U.S. Department
of Transportation
**Federal Highway
Administration**

In Reply Refer To: HSA-10/SS-127

Thank you for your letter of October 22, 2004, requesting the Federal Highway Administration (FHWA) acceptance of revisions to your company's Slip-Mate slip base as a breakaway sign support system for use on the National Highway System (NHS). Accompanying your letter were drawings of the proposed changes. You requested that we find the revised Slip-Mate breakaway base acceptable for use on the NHS under the provisions of the NCHRP Report 350 "Recommended Procedures for the Safety Performance Evaluation of Highway Features." You also requested that products formally tested and accepted under the "Western Highway Products" name and sold by your company be recognized as "Ulti-Mate" products.

SUB-ASSEMBLY SECTION VIEW DETAILS

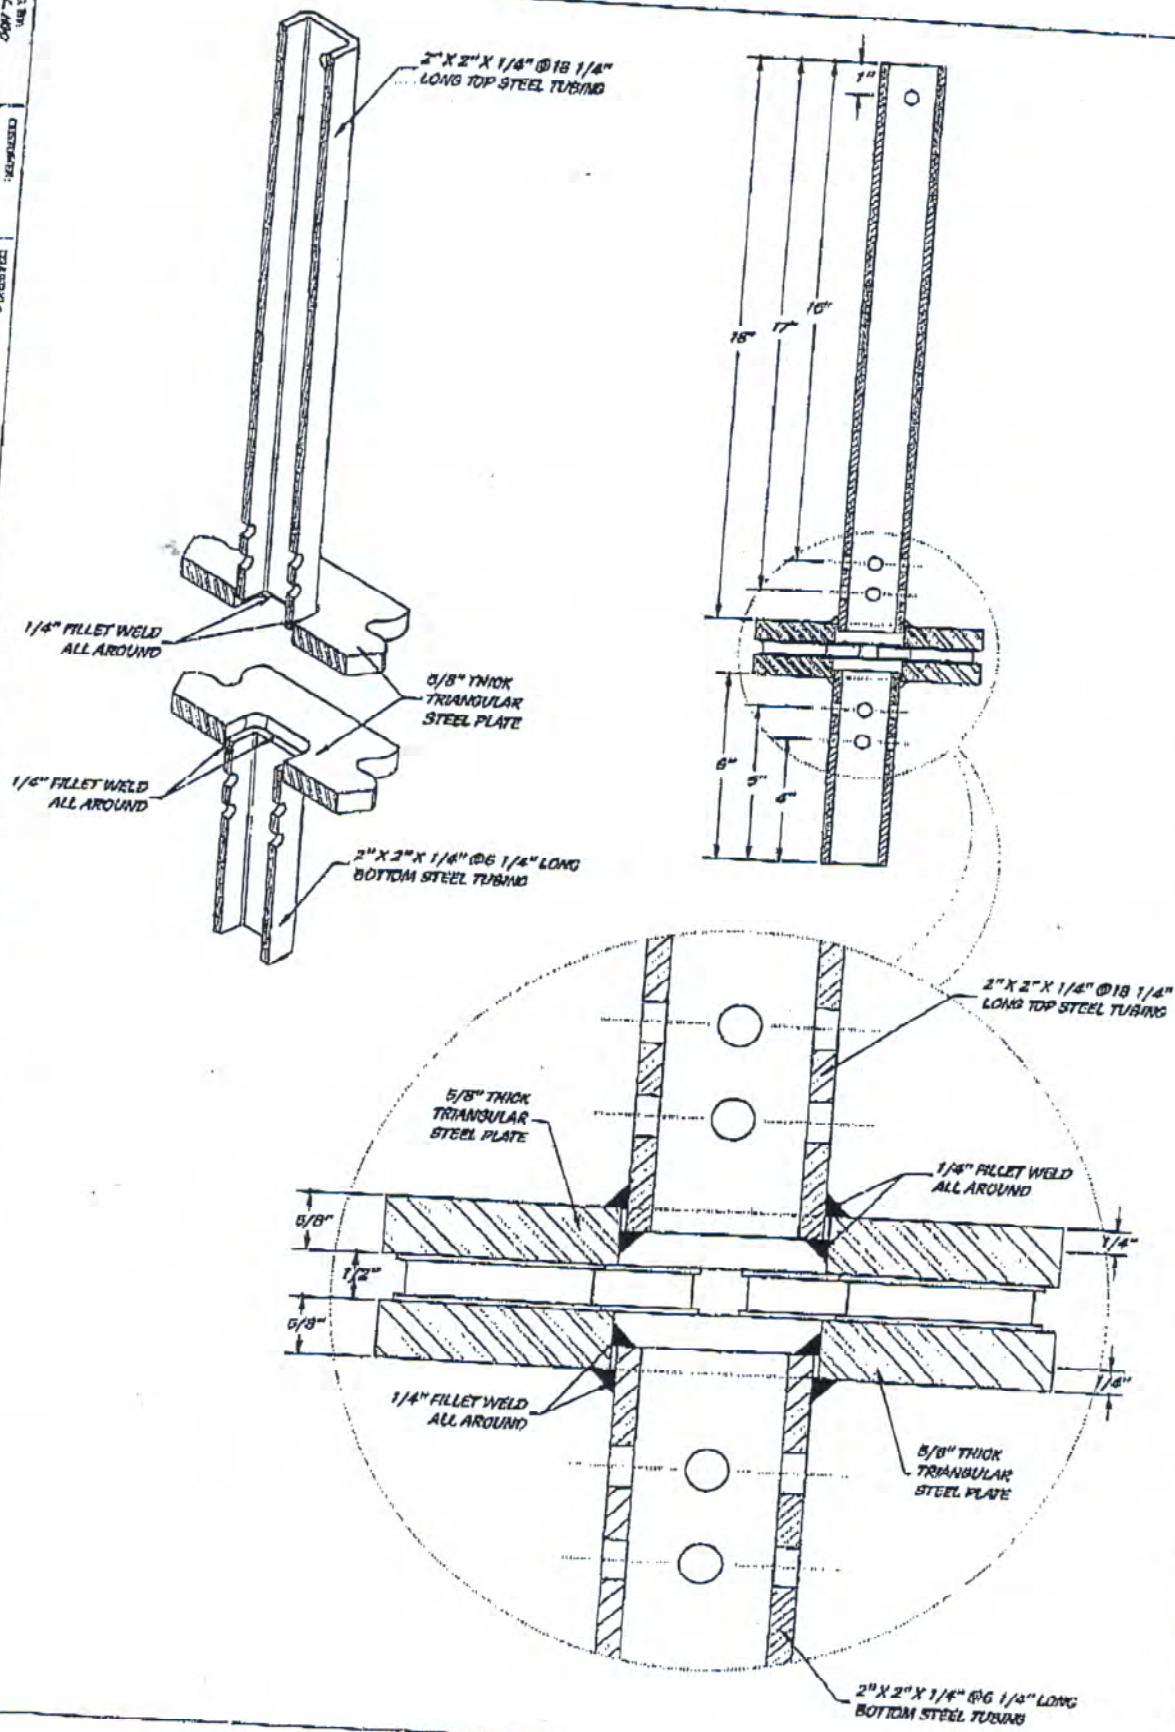
- Increase the triangular steel plate thickness from 1/2-inch to 5/8-inch
- Cut square holes in the upper and lower plates such that the 2-inch PSST may be inserted half way into the plate. Fillet weld all around on the lower and upper joint areas.
- Weld 1/16-inch thick gasket to 3/8-inch thick gasket in place of adhesive. This will help to keep the stainless steel ball bearings in place.

We concur with your assertion that these changes should have no adverse affect on the breakaway performance of the Slip-Safe system. Therefore, the modifications to the devices described above and shown in the enclosed drawings for reference are acceptable for use as Test Level 3 devices on the NHS under the range of conditions tested, when proposed by a State.
